भारत सरकार / Government of India  
विद्युत मंत्रालय / Ministry of Power  
केन्द्रीय विद्युत प्राधिकरण / Central Electricity Authority  
विद्युत प्रणाली योजना एवं परियोजना मूल्यांकन प्रभाग - I  
Power System Planning & Project Appraisal Division-I  
सेवा भवन, आर.के.पुरम, नई दिल्ली - 110066  
Sewa Bhawan, R. K. Puram, New Delhi-110066

**Subject: Minutes of 38<sup>th</sup> Standing Committee Meeting on Power System Planning of Northern Region held on 30<sup>th</sup> May, 2016, at NRPC, Katwaria Sarai, New Delhi.**

**Minutes of 38<sup>th</sup> Standing Committee Meeting on Power System Planning of Northern Region  
held on 30<sup>th</sup> May, 2016, at NRPC, Katwaria Sarai, New Delhi.**

### **Tapovan Vishnnugad HEP:**

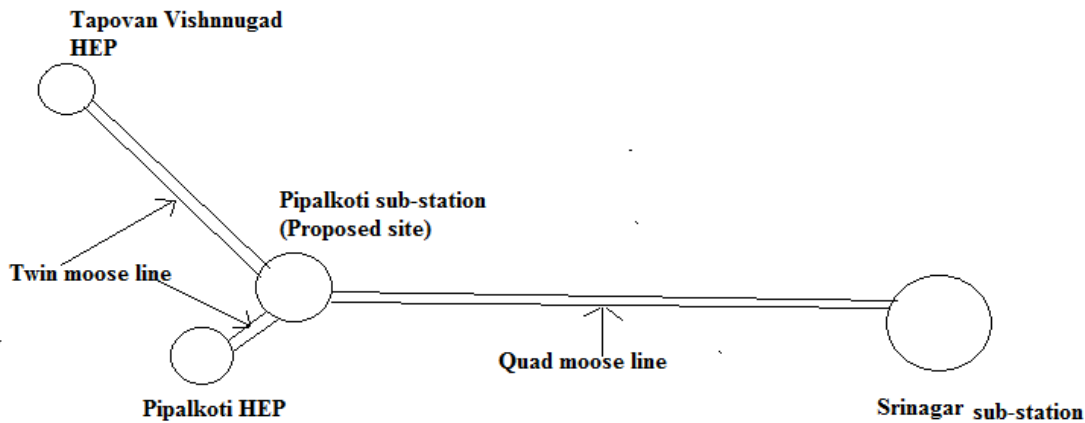
5.3 Director (PSP&PA-I), CEA further stated that for evacuation of power from Tapovan Vishnugad HEP, PTCUL shall construct 400 kV D/C line with twin conductor from Tapovan Vishnugad HEP to the proposed site of Pipalkoti substation and 400 kV quad line from the proposed site of Pipalkoti substation to Srinagar. Accordingly, there would be a direct connectivity between twin moose and quad moose lines at the proposed Pipalkoti substation and hence switching station would not be required till September, 2018 when Tapovan Vishnugad HEP is scheduled to be commissioned.

5.4 As Pipalkoti HEP would be commissioned in December, 2019, the same shall be evacuated by constructing a 400kV switching station at Pipalkoti. Subsequently, 400/220 kV ICTs would be required at Pipalkoti switching station as per the timelines for commissioning of the HEPs in Alaknanda valley.

5.6 DGM, NTPC stated that the revised commissioning schedule of Tapovan Vishnugarh HEP is March, 2019 instead of September, 2018 intimated during the meetings held in CEA. DGM, POSOCO stated that for 400kV GIS substation, the one and half breaker bus bar arrangement should be implemented.

- (i) 400 kV D/C (Twin Moose) Tapovan Vishnugad HEP –Pipalkoti S/stn (Proposed site) line

(ii) 400 kV D/C (Quad Moose) Pipalkoti S/stn (Proposed site) - Srinagar line

**After deliberations, the above evacuation system was agreed by the members with the above timeframe.**

## 16.0 Connectivity to Dhaulasidh Hydro Electric Power Project (66MW) of M/s SJVNL in Himachal Pradesh

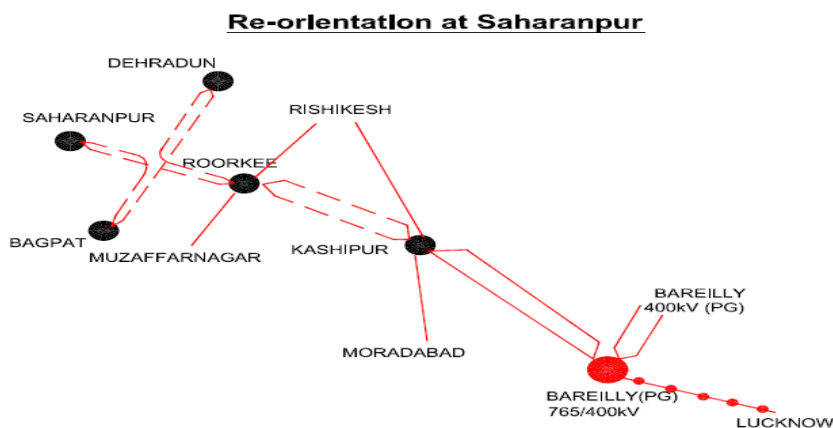
16.1 Director (PSP&PA-I), CEA stated that the connectivity application from M/s SJVN Ltd. for 66 MW (Plus 10% inbuilt overload capability to meet grid requirement) was discussed during the 7<sup>th</sup> & 8<sup>th</sup> Meeting of Northern Region Constituents for Connectivity/Long Term applications held on 14/07/2015 and 20/01/2016 respectively. The LTA application is yet to be received. Powergrid had proposed to grant Connectivity to M/s SJVNL for Dhaulasidh HEP through Dhaulasidh HEP – Hamirpur (PG) 220 kV D/C line. He further added that as the installed capacity of 66 MW is small quantum, evacuating the same at 220 kV would be *a non-optimal transmission plan*.

16.2 After deliberations, it was decided that a meeting would be called by CEA with CTU, SJVNL and HPPTCL/HPSEBL.

**Schematic diagram of the contingency arrangement is as shown below:**

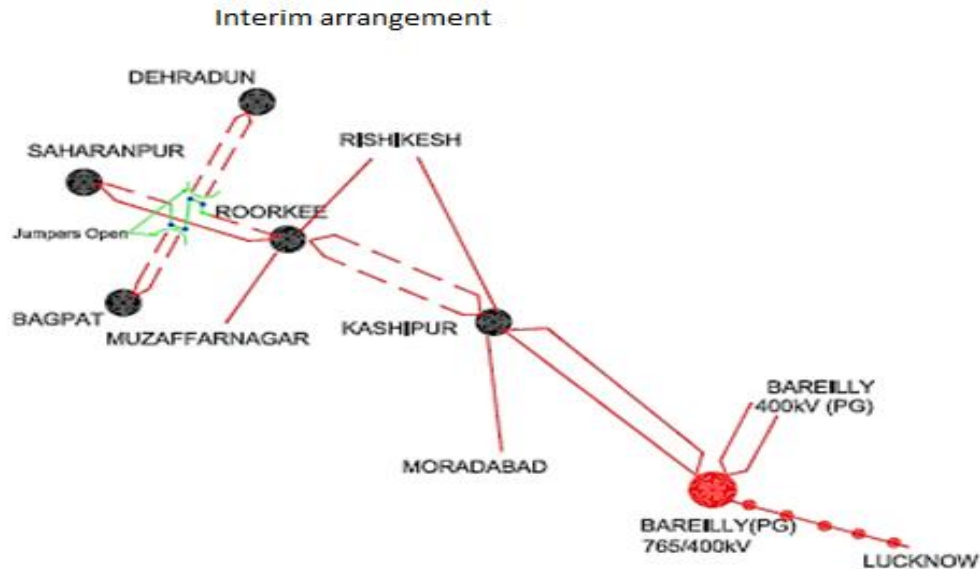
power flow through 400kV Roorkee – Saharanpur S/C line is about 250– 300MW. Considering reliability of power supply to Saharanpur substation, it is proposed to charge the 2<sup>nd</sup> circuit of 400kV Roorkee- Saharanpur line (made ready after contingency arrangement at re-orientation point).

**Members concurred the same.**
